Date September 13, 2018
To Town of Cumberland Planning Board
From Carla Nixon, Town Planner
Subject **Major Site Review: Library Parking Expansion**

PEER REVIEW ENGINEER'S COMMENTS: Al Palmer, P.E., Gorrill Palmer Engineers

Site Plan Review Application

SITE PLAN

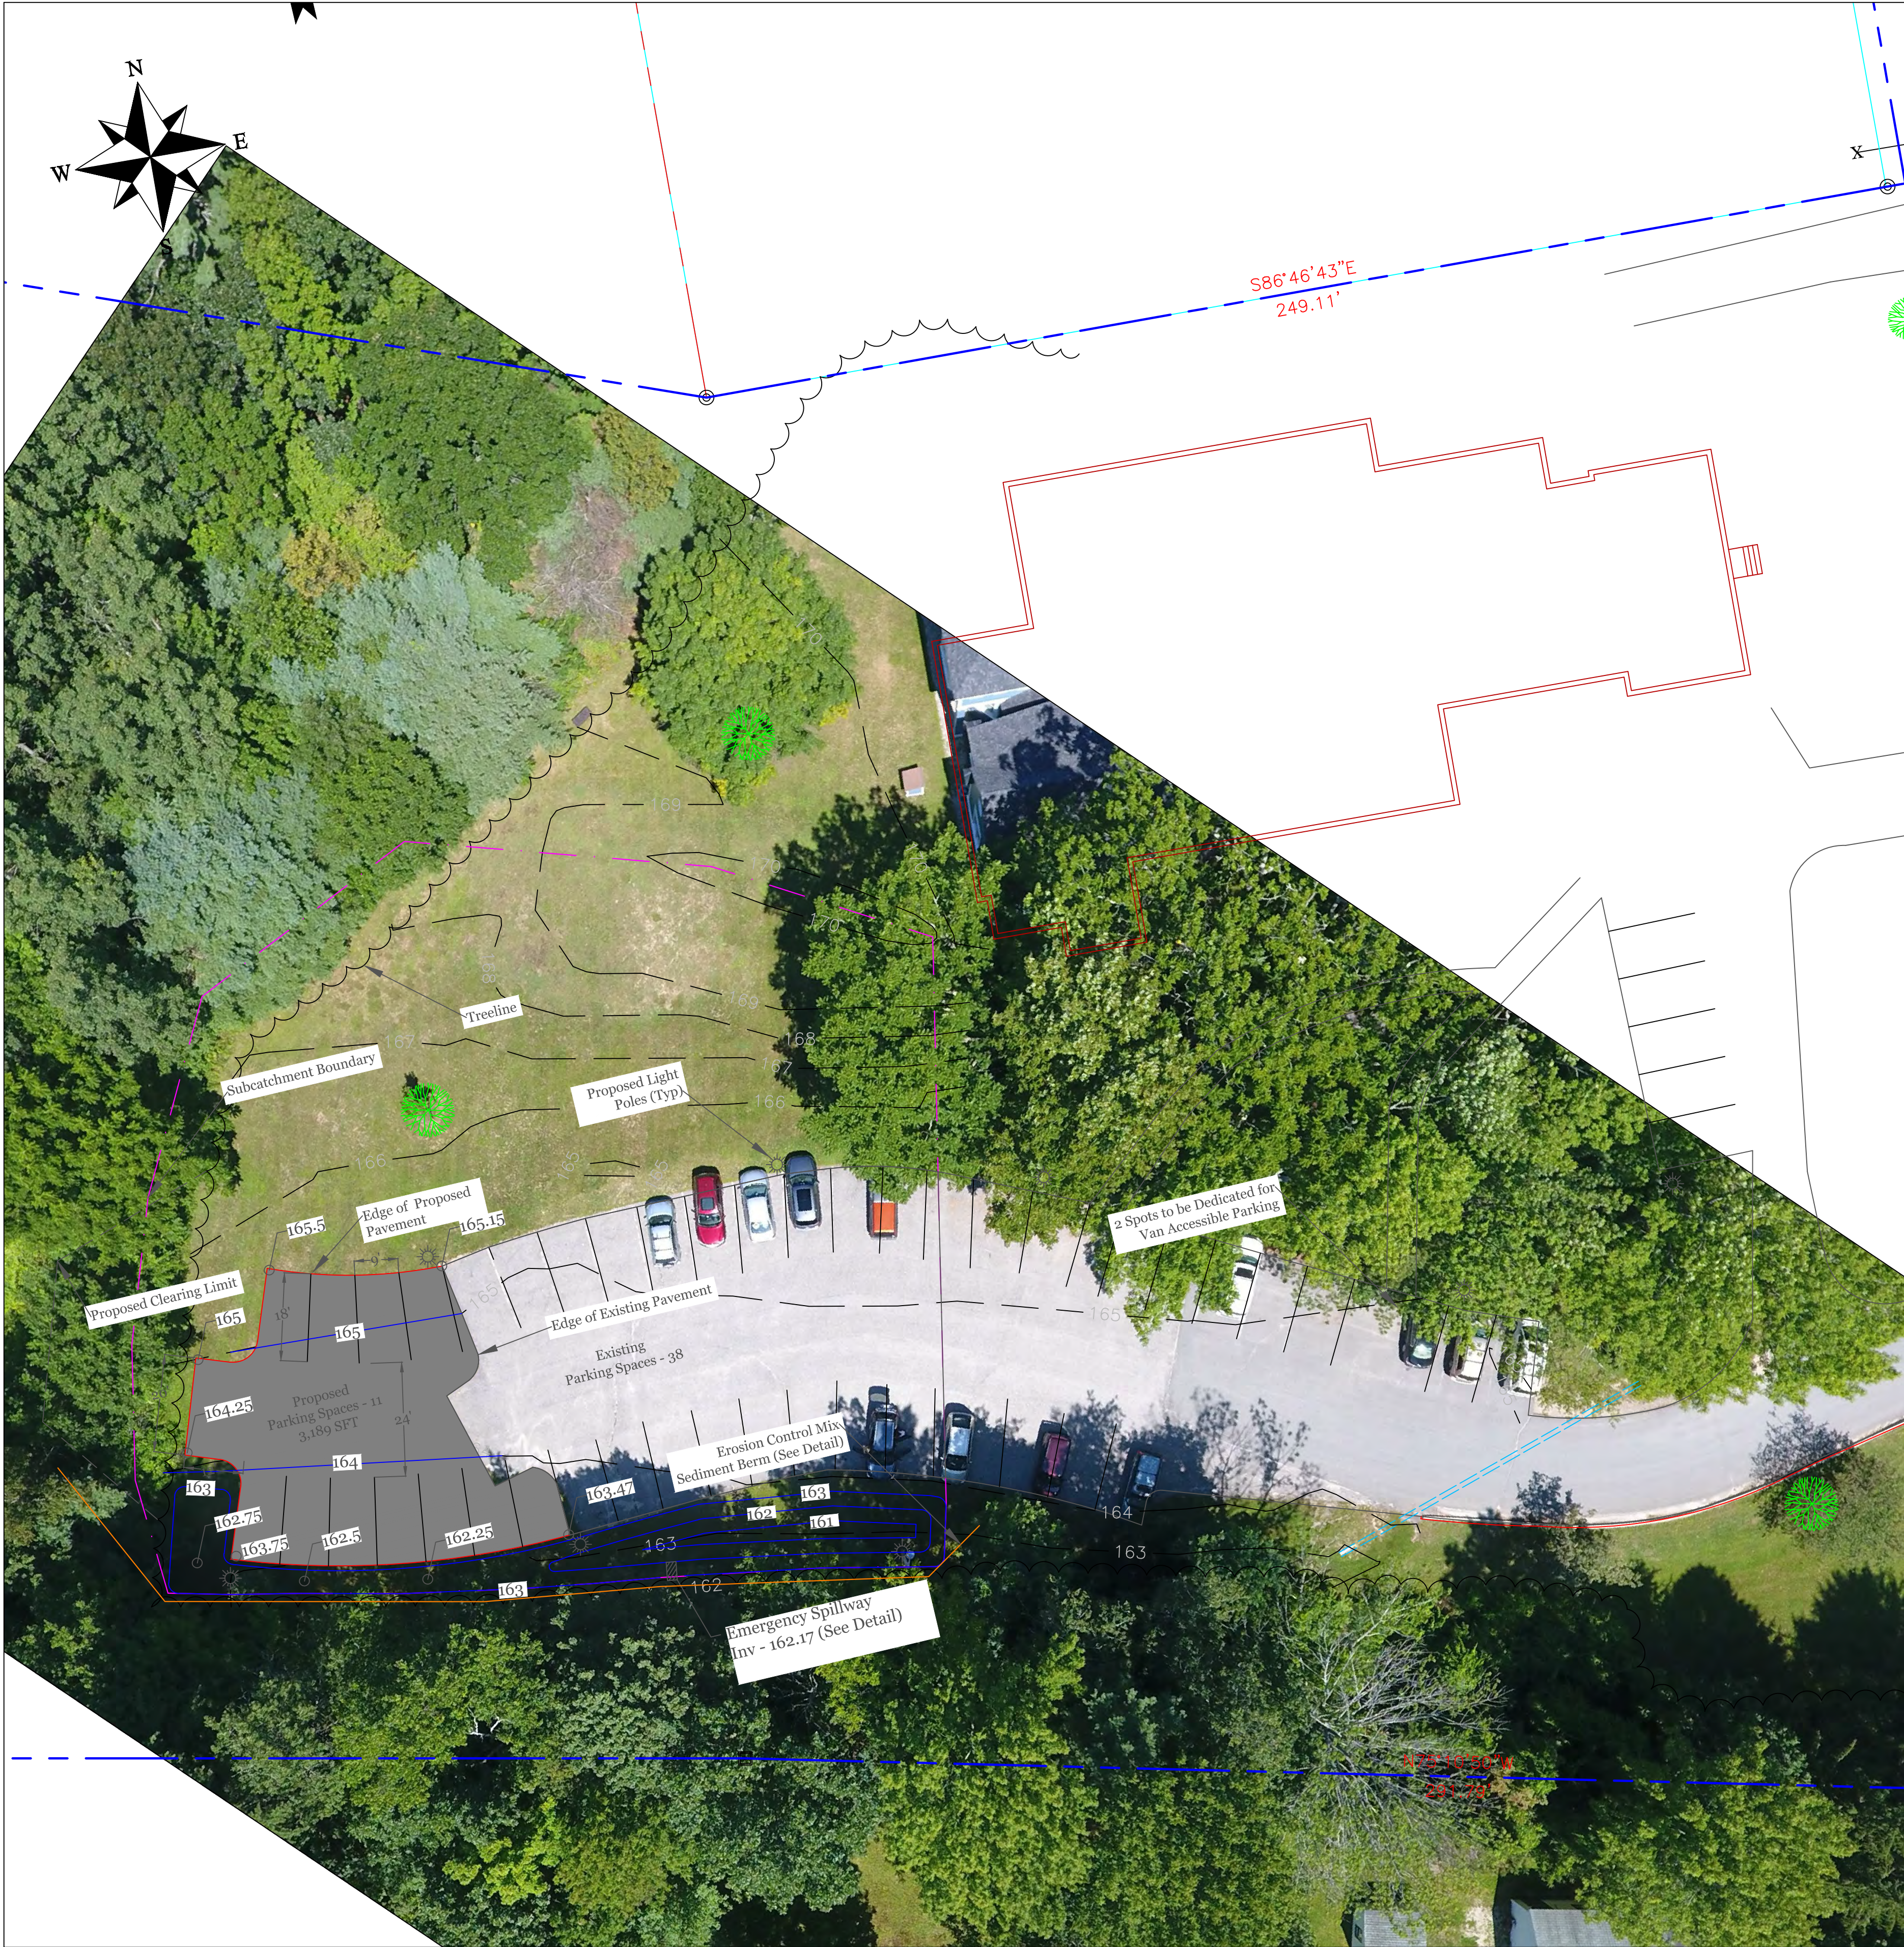
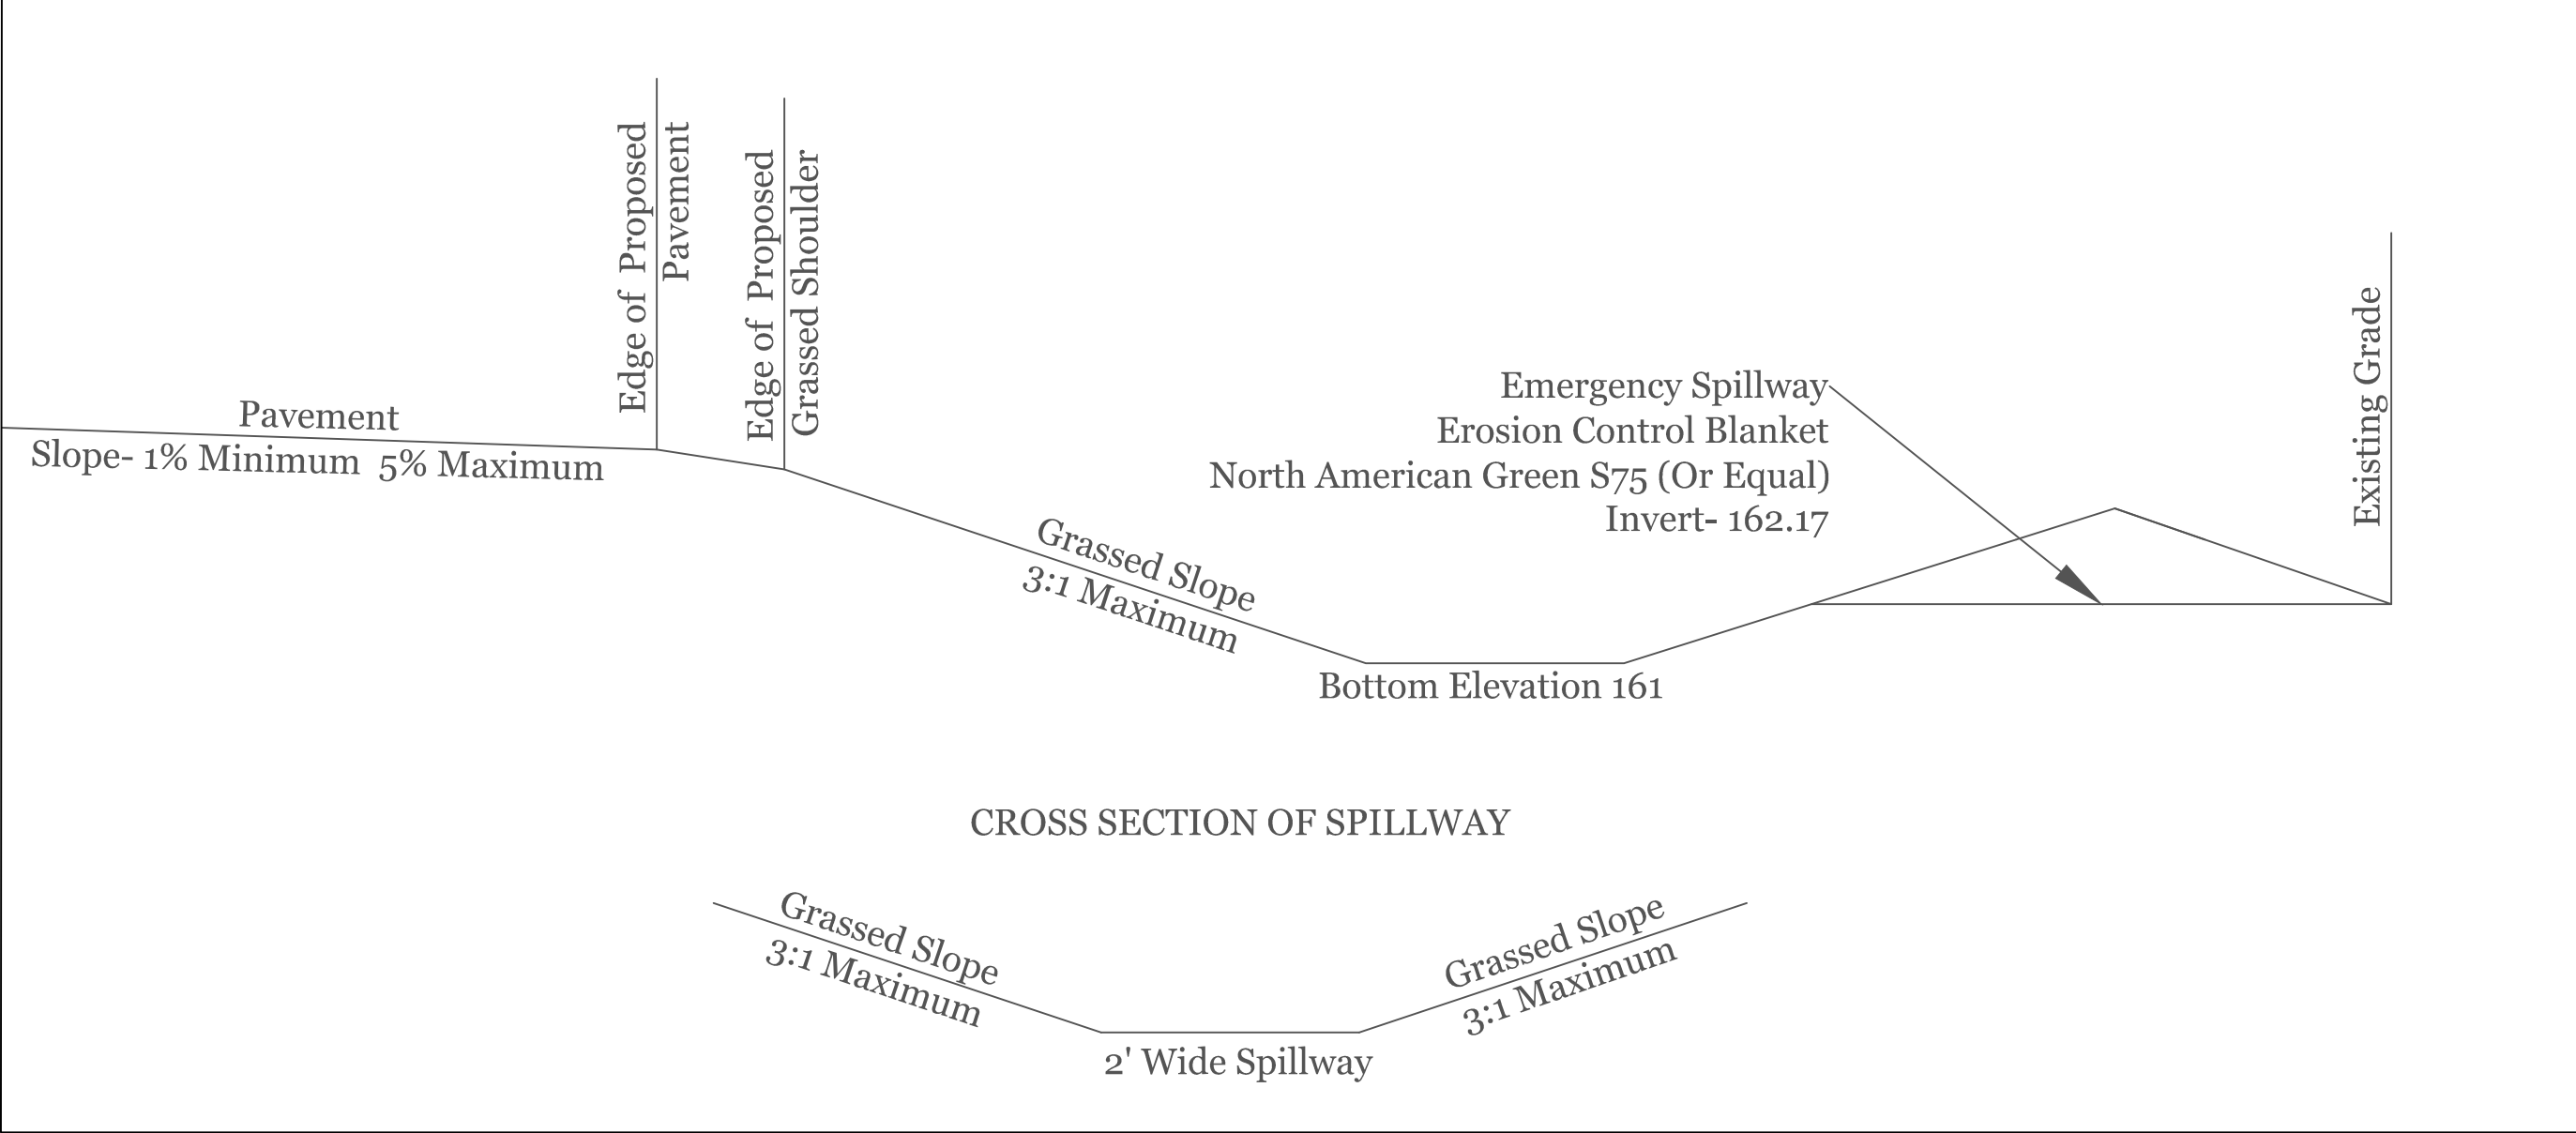
- a. Neither the Survey nor the Site Plan depict any barrier free parking spaces. We recommend that the Designer evaluate and confirm compliance with the American with Disabilities Act (ADA) relative to parking and access routes.

- b. What horizontal control will be provided to assist the Contractor with the layout of the parking lot?

- c. We would recommend that the Designer consider addition of spot grades at all corners of the parking lot.

- d. We would recommend that the turnaround area be dimensioned.

- e. As the Property Line is not shown on the Site Plan, we would **recommend addition of a note that states “Parking lot expansion shall be a minimum of 15’ from property line” to comply with Section 10.2.4.2 of the Site Plan Review Ordinance.**

- f. We would recommend that the proposed clearing limits be shown on the Site Plan.

- g. The proposed driveway cross slope at the westerly end of the parking lot is approximately 4.5%. Is this desirable?

- h. Typical riprap depth is 2.25 times the D50 diameter versus the 1.5 times provided in the detail.

- i. We would recommend that the Designer provide a cross section through the riprap spillway to aid the Contractor in construction.

- j. Based on the stormwater modeling, the principal spillway is not activated until ponded stormwater reaches elevation 162.75'. How will this be accomplished if riprap is used at the base of the spillway?

There are five (5) handicap accessible parking spaces. Three at the entrance to the library and two in the lower lot. Which is sufficient for the 59 total proposed parking spaces according to the 2010 ADA standards which requires 3 spaces for up to 75 parking spaces.

The contractor will need to establish control based on the existing survey.

Spot grades have been added at each corner and along the edge of the proposed parking lot.

Dimensions for the turnaround have been added.

The suggested note has been added to the Site Plan.

No clearing is proposed.

The spot grades should help clarify the slopes. The turnaround has the steepest slopes as the proposed grading ties into existing and is 3.75%. The parking areas are all closer to 2%.

The riprap has been removed in favor of an erosion control blanket. The flows are less than 2 cfs and the downstream slope is less than 2%.

A cross section has been provided for the spillway.

The riprap has been replaced with an erosion control blanket.

DETENTION POND DETAIL (NTS)

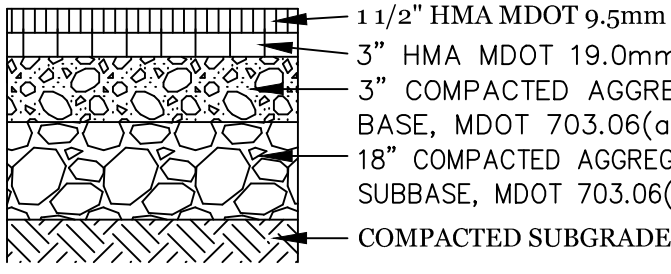
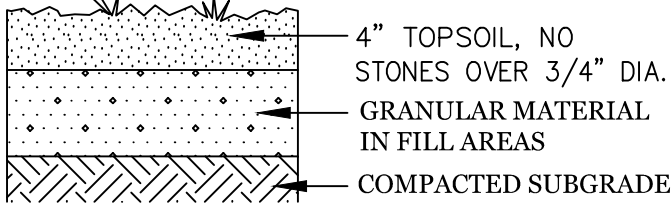
3. With respect to the Stormwater Analysis, we offer the following comments:
- a. The Stage Storage calculations for the detention basin includes a surface area of 150 square feet at elevation 61. It did not appear that **the 61' contour was shown on the Site Plan.**

- b. Is the Designer comfortable that a broad-crested rectangular weir will accurately represent a riprap spillway from a stage-discharge standpoint?

- c. **The calculations indicate a 5' long x 1' breadth weir, while the Site Plan indicates a 2' x 6' riprap spillway.** Please confirm desired sizing.

- d. **The top of the detention basin berm appears to be at elevation 63', is graded to a "point" and has no width to** the top of the berm. We would **recommend that the Designer consider having a 4' wide berm at the top** of the detention basin.

- e. As currently modeled, the water surface elevation in the basin for the **25 year storm is elevation 162.98'. This provides 0.02' of freeboard to** the top of the berm. We would recommend that the Designer consider **providing a minimum of 1' of freeboard from the 25 year storm water** surface elevation to the top of berm.

- f. As currently modeled, the ponded water for the 25 year storm is within **approximately 1' of the edge (horizontal) of the expanded parking lot.** Is this desirable?

- g. As currently designed, the only manner for stormwater discharge **between elevation 161' (bottom of basin) and 162.75' (spillway** elevation) is by surface infiltration. We would recommend that the Designer consider an alternate discharge method (such as an infiltration trench or a low flow piped discharge at elevation 161) in the event of frozen ground or other factor that may limit surface infiltration. This could avoid an extended period of ponded water in the basin after a storm.

- h. It appears that the spillway is located in a filled area. We would recommend that the Designer consider relocating the discharge to a cut area, or provide a compaction standard for the berm.

A 161' contour has been added to the plan.

The outlet has been changed to a sharp crested weir.

The riprap refers to the area being riprapped. The dimensions of the outlet in the model have been adjusted to a sharp crested weir 2' wide.

The outlet to the pond is nearly at existing grade. The pond will be mostly cut, and the top of the berm will be a small earthen hump. The width of the berm will be depended on how much space the contractor feels is needed for compaction.

Additionally, the minimal flows and height of the berm would make 4' unnecessary. One of the design intentions was to minimize the footprint of the project and not impact the tree line. As the model shows the required detention is barely achieved, making each foot of storage space precious.

The outlet elevation has been dropped to provide **6" of freeboard during a 25-year** storm. This freeboard is sufficient for 1.61 cfs of flow. It would be acceptable for the berm to function as a level spreader and be over topped if necessary.

By lowering the outlet elevation, there is nearly 3' from the ponded water to edge of the parking lot.

In order to daylight a **pipe in the bottom of a trench with a top at 161'** would require running the pipe outside the tree line and towards the abutters. This would create a concentrated flow (even with a level spreader) that may negatively impact the abutting property. The infiltration rate used was the most conservative for the soils on site. Lowering the outlet also helps alleviate this concern.

The proposed spillway has been dropped to existing grade (or very near).
